**Moorhead Area Public Schools Improvements
Robert Asp Elementary School Addition
Moorhead, MN**

**Project No. 13-041
Date: April 4, 2014**

ADDENDUM No. 2

Sheet No. SA-I

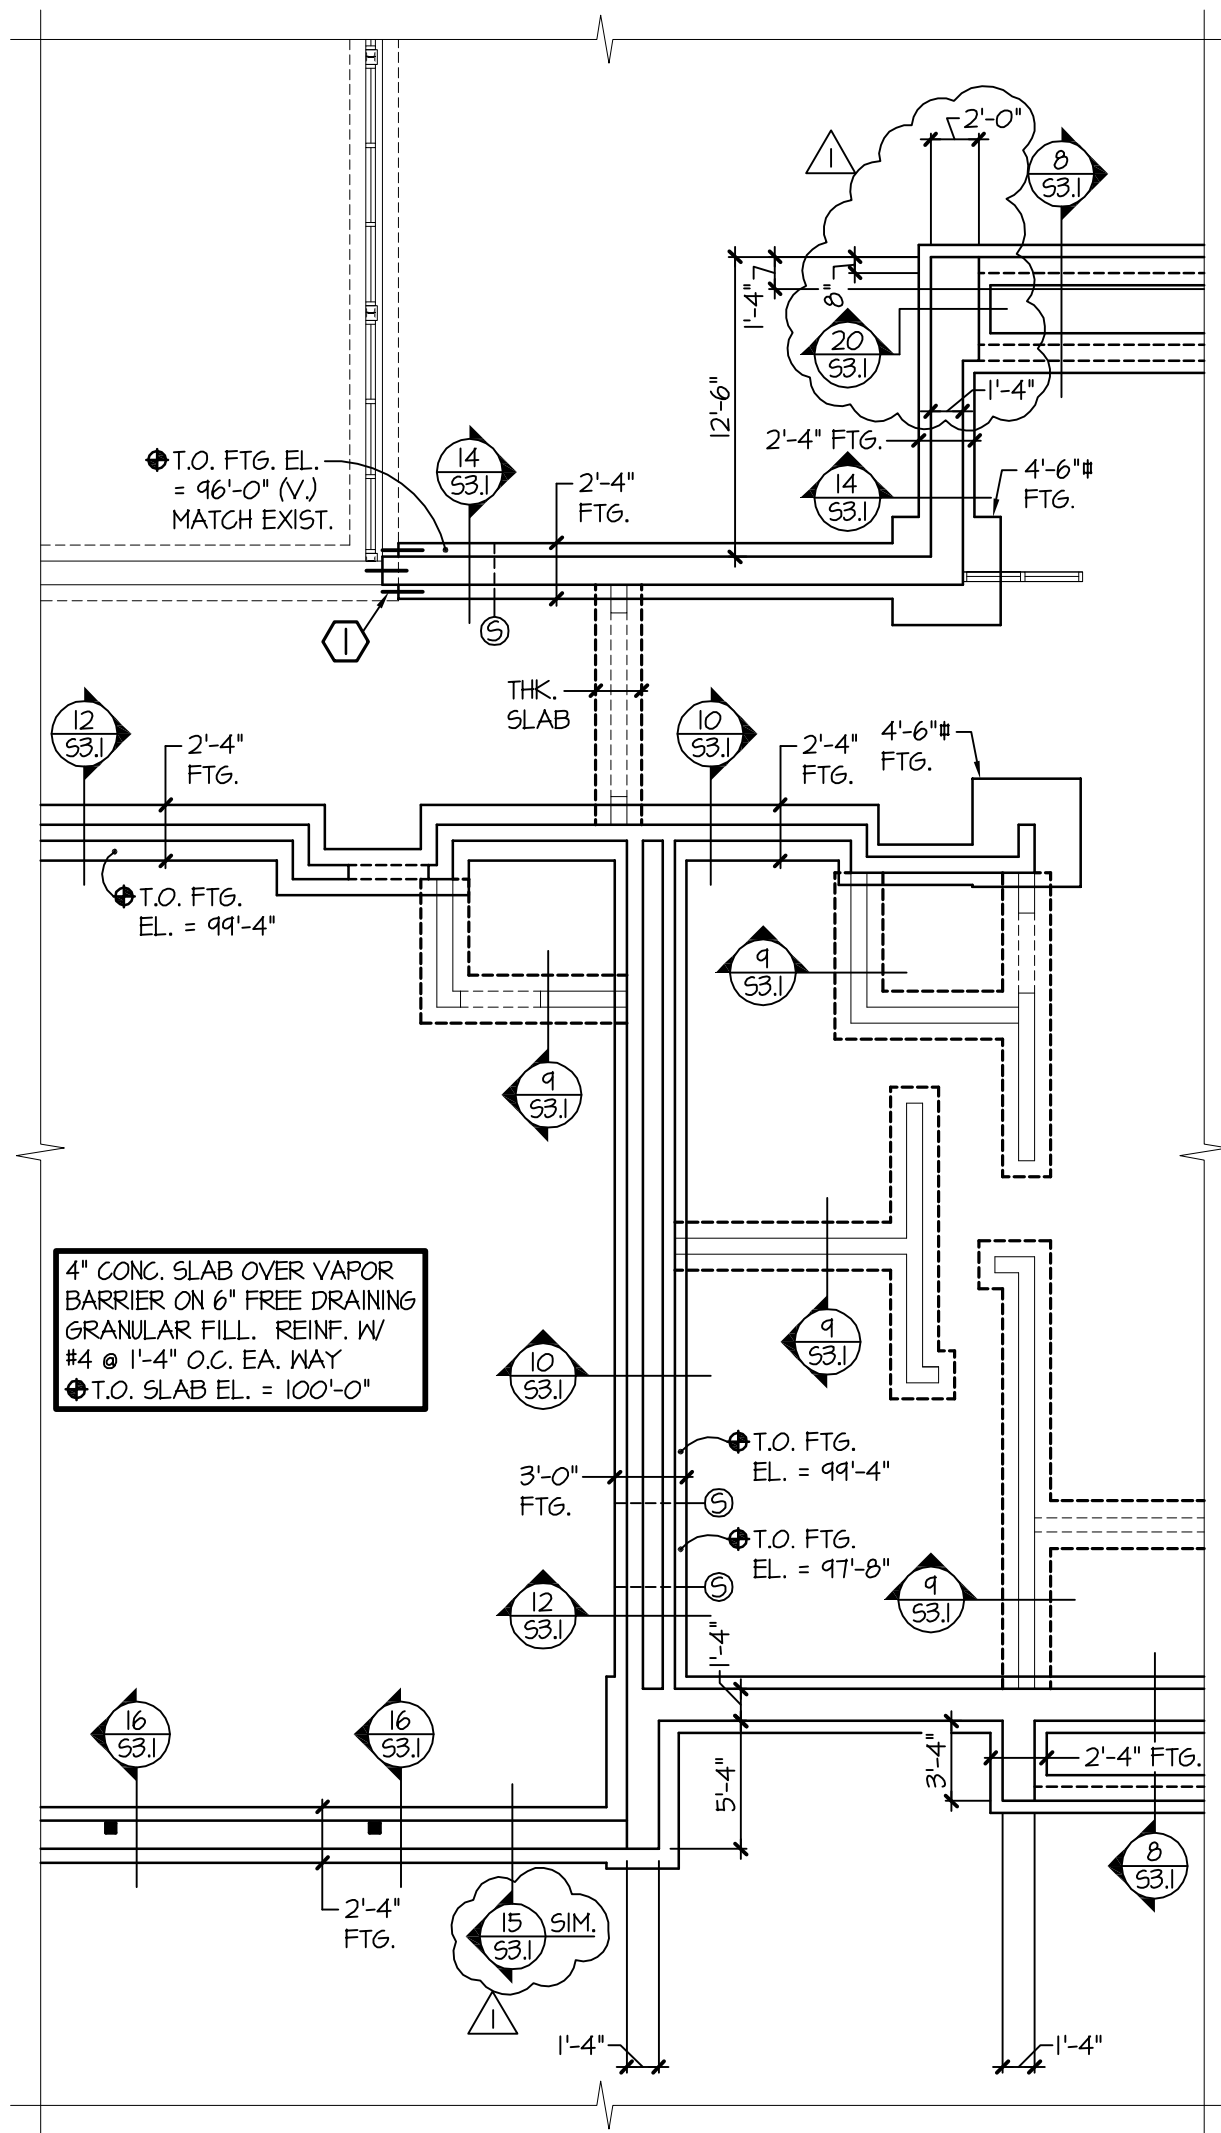
(PARTIAL)
FOOTING & FOUNDATION PLAN
 1/8" = 1'-0" T.O. FTG. EL. = 96'-0" (U.O.N.)

Sheet No. SA-2

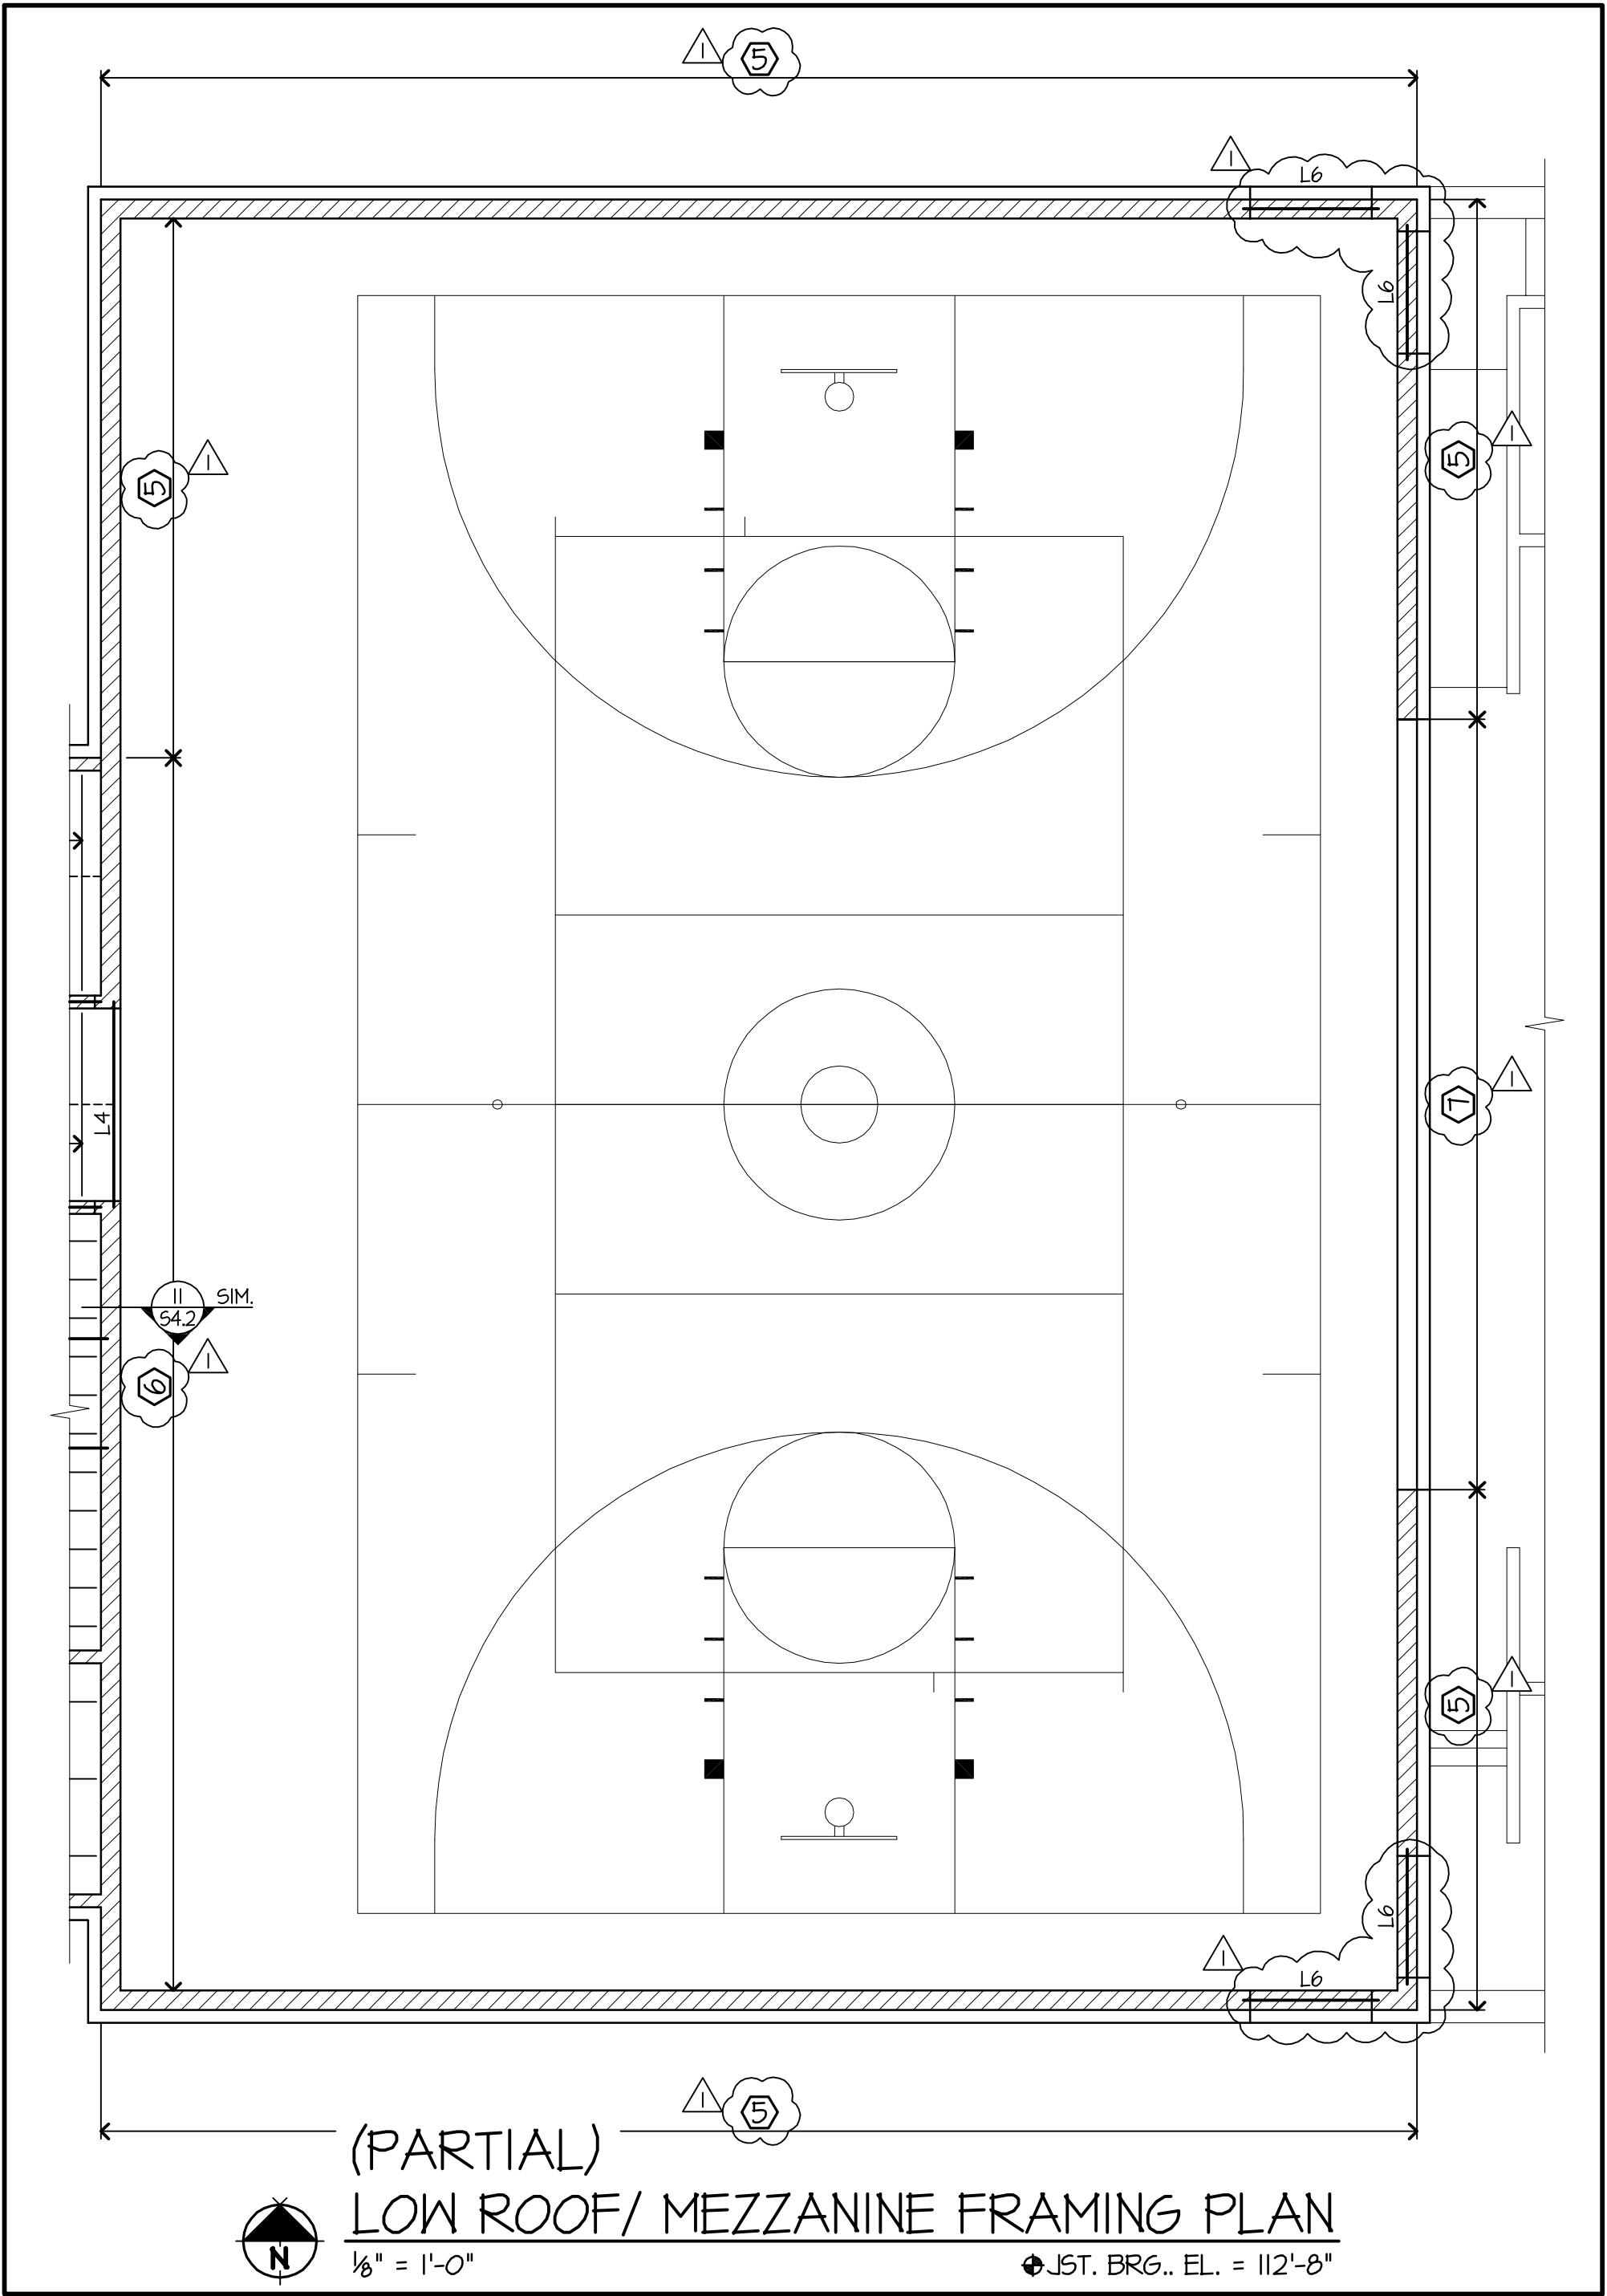
2. POCKET & BEAR NEW BEAM ON EXISTING CMU WALL. SIMILAR TO DETAIL 1/54.2 GROUT CORES SOLID BELOW BEAM IF NOT GROUTED ALREADY.
3. 4" TOTAL THICKNESS MECHANICAL FLOOR SLAB OVER 1", TYPE 'C' 226A. DECK OVER 10K1 STEEL JOISTS @ 2'-0" O.C. S.D. 11/54.1 REINF. W/ 6x6 - W2.9xW2.9 OR NOVOMESH 850 OR EQUIVALENT.
4. 4" TOTAL THICKNESS MECHANICAL FLOOR SLAB OVER 1", TYPE 'C' 226A. DECK OVER 16K2 STEEL JOISTS @ 2'-0" O.C. S.D. 11/54.1 REINF. W/ 6x6 - W2.9xW2.9 OR NOVOMESH 850 OR EQUIVALENT.
5. REINF. 12" CMU WALL W/2 - #5 @ 2'-0" O.C. S.D. 14/54.1 (PLACE BARS 3/4" FROM EACH FACE SHELL).
6. REINF. 12" CMU WALL W/2 - #5 @ 4'-0" O.C. S.D. 14/54.1 (PLACE BARS 3/4" FROM EACH FACE SHELL).
7. 10005200-68 METAL STUDS @ 1'-4" O.C.

Project	Moorhead Area Public Schools Improvements	Sheet No.	SA-6
	Robert Asp Elementary School Addition	Job No.	094.0054.2013
	Moorhead, Minnesota	Date	4.2.2014
Re	Addendum I - Ref. Sheet - 52.2	By	EAG/CH

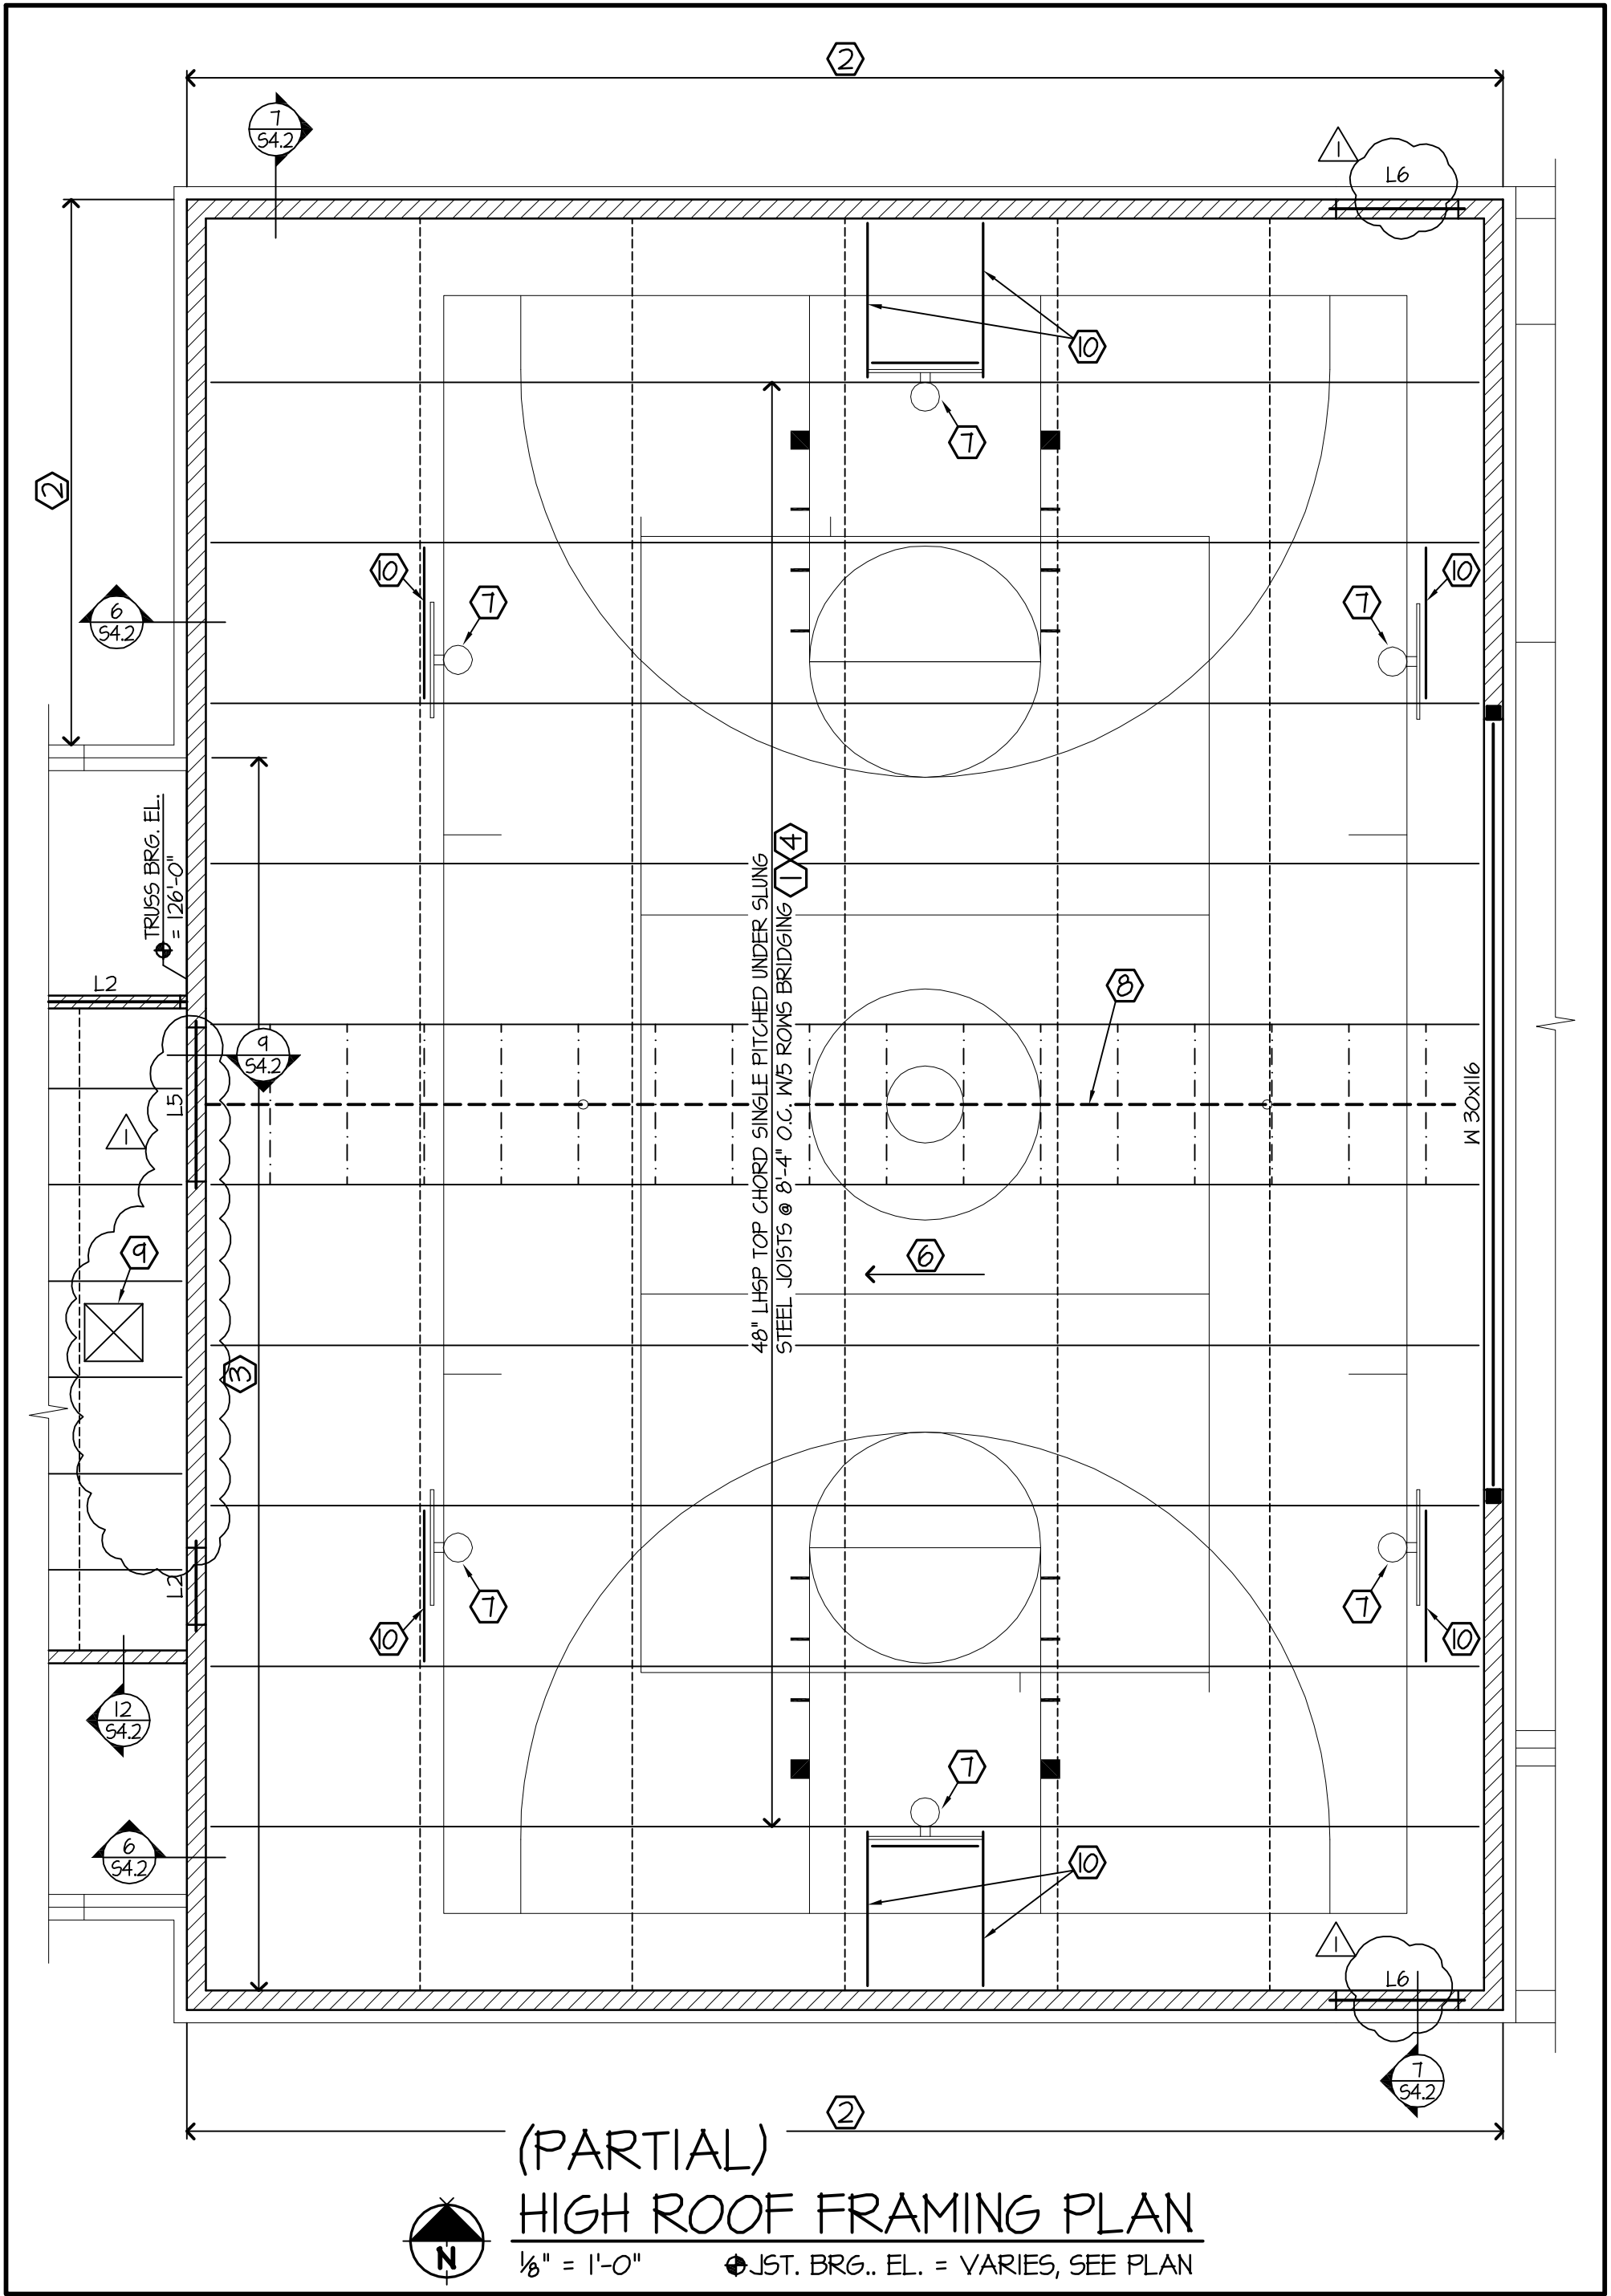
6 SLOPE TOP CHORD 1/4/FT., SEE ARCH.

10 L 4 x 4 x 3/8" SUPPORT BETWEEN JOIST & BETWEEN JOISTS & WALL FOR GOAL SUPPORT. VERIFY SUPPORT REQUIREMENTS W/ GOAL SUPPLIER.
